Ziebarth Associates

Re: Plaza De Panama –Balboa Park Draft EIR Review

After reviewing a significant portion of the DEIR, though admittedly not all of it, I have significant concerns about the analysis. I wish that I would have had more time to provide more detailed comments, but the following are my comments and observations on the Draft Environmental Impact Report (DEIR) for the Plaza De Panama Project in Balboa Park:

Alternative to the Proposed Project

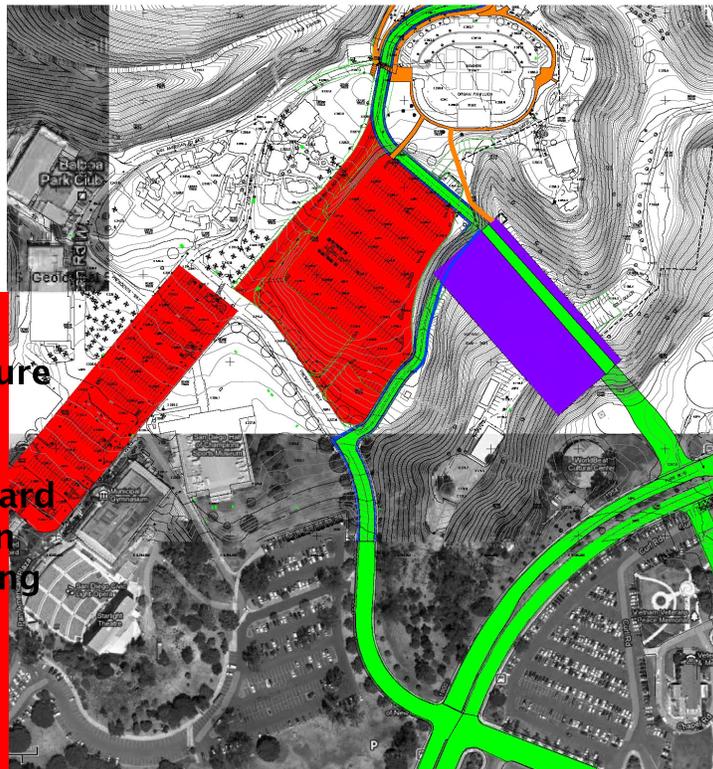
1. Add 78 spaces on Balboa Drive
2. Disabled & Drop Off Built in Alcazar
3. Modify Park Road to create Bike Lane
4. Narrow Mall Roadway
5. Eliminate Parking in Plaza de Panama

Alternative:

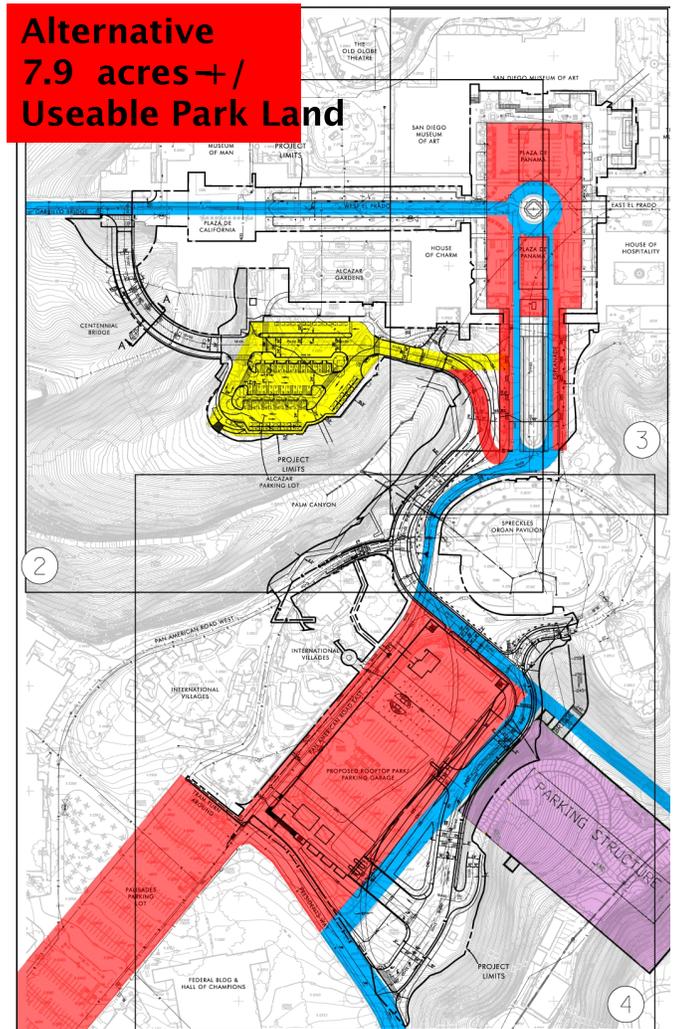
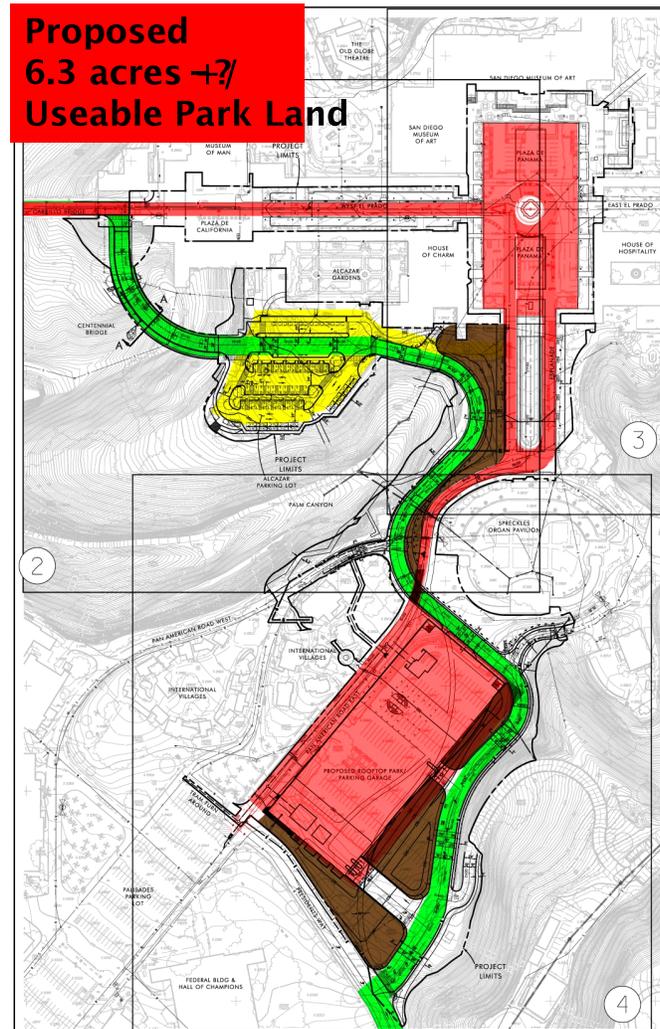
1. Parking Structure In Gold Gulch
2. Road Connect to Park Boulevard
3. Convert Organ Pavilion Parking & Palisades Parking to Useable Park Land

Proposed Project Circulation

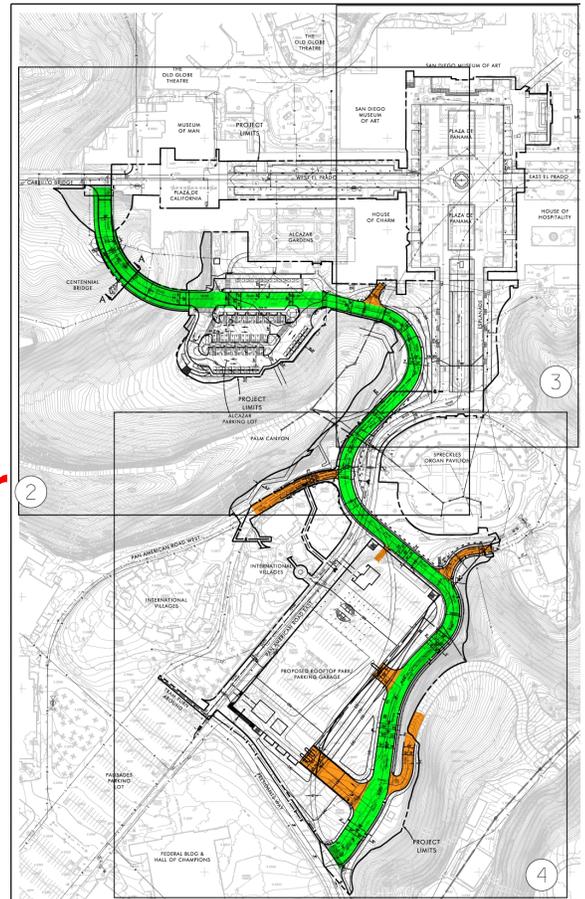
1. Induce Traffic?
2. Safer?
3. Discriminator
4. Accessibility Impact?

**Proposed
Project
Circulation**
Or
**Existing
Circulation**

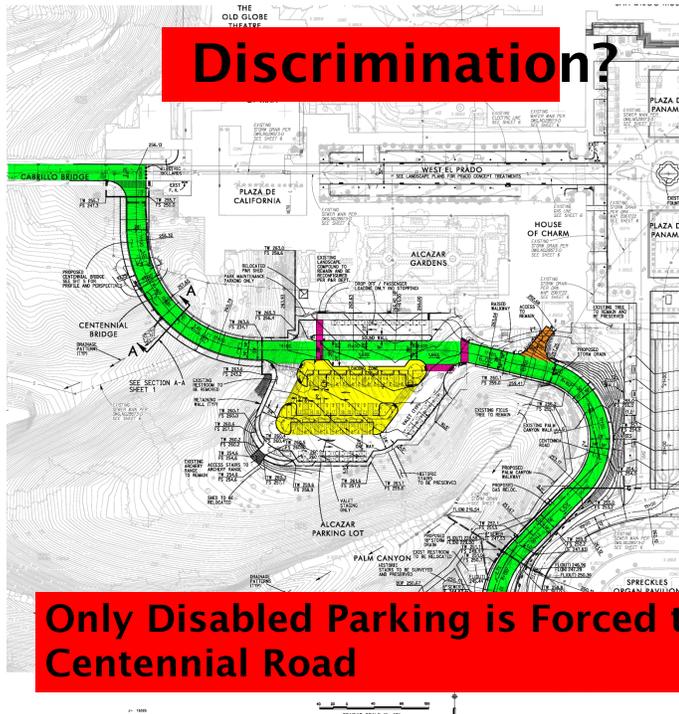
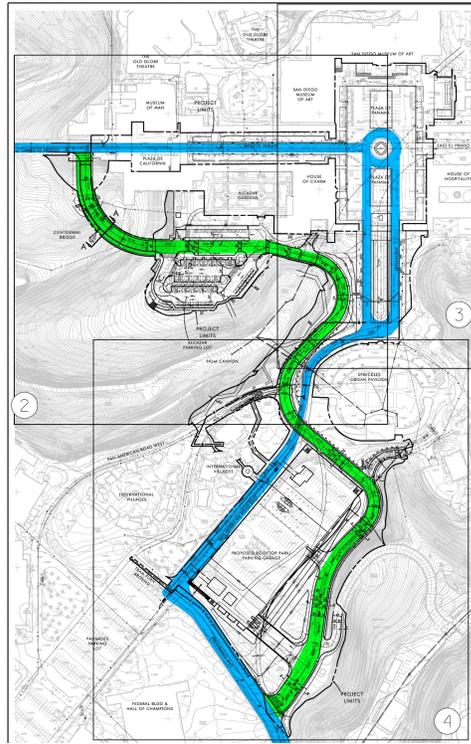
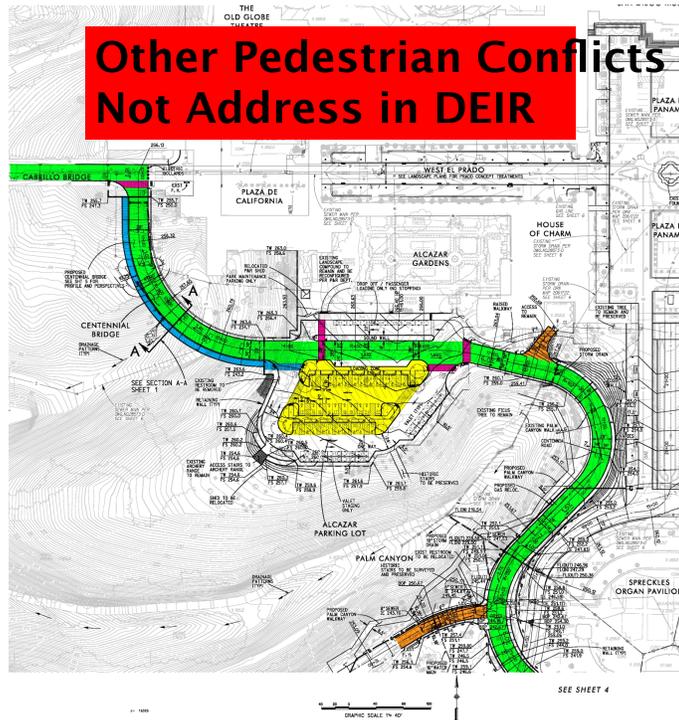
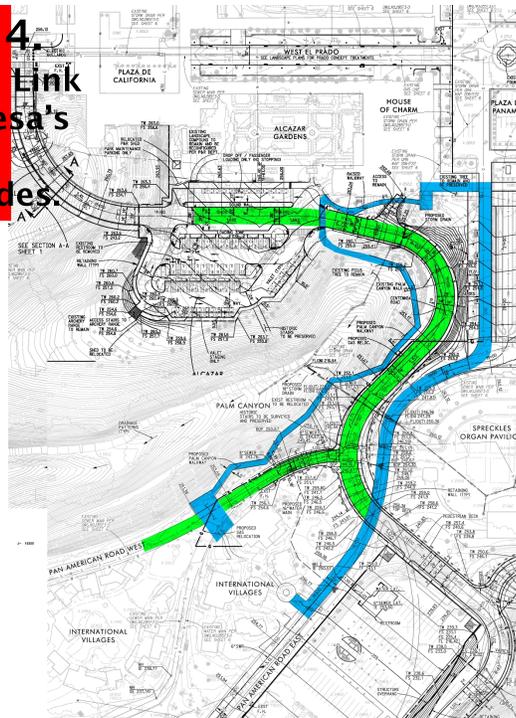
**Project Objective 4:
Improve the Pedestrian Link
Between the Central Mesa's
two cultural cores:
El Prado and the Palisades.**

Section – Parking Structure/Rooftop Park

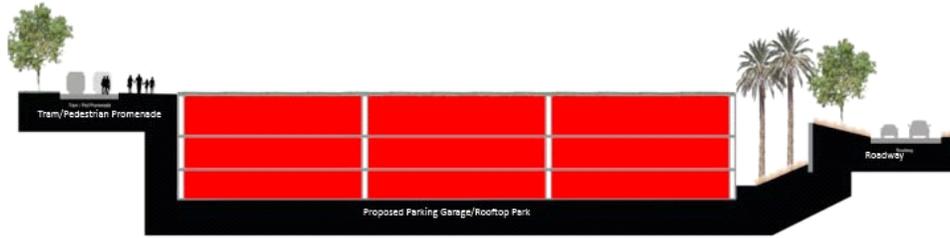
Does this Make Sense or is It a Solution being
